Product/Process Change Notice (PCN)

PCN #: PCN_IndLF_20180328

Product Affected: WE-LF Series 744662xxx

PCN Date: December 28th, 2017Effective Date: March 28th, 2018

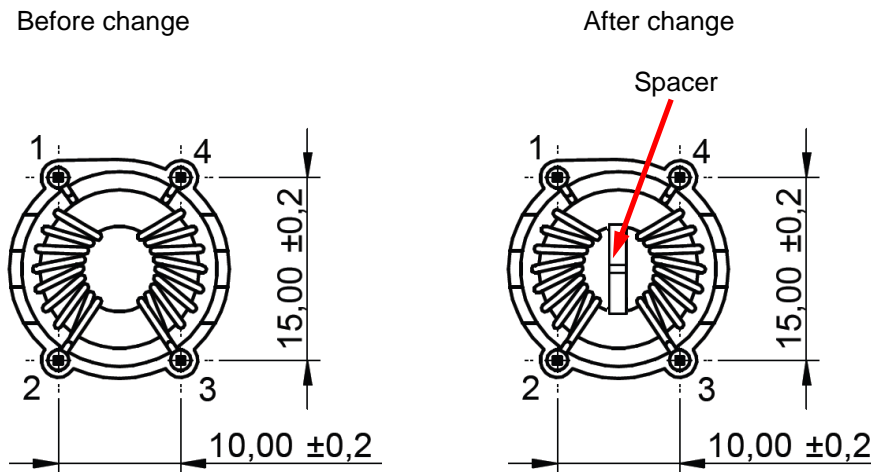
Due to a continuous product improvement process, Würth Elektronik will add a spacer between the separated windings to insure the required minimal creepage distance.

The spacer material will be Ultramid A3X2G5 from BASF with UL-File number E36632.
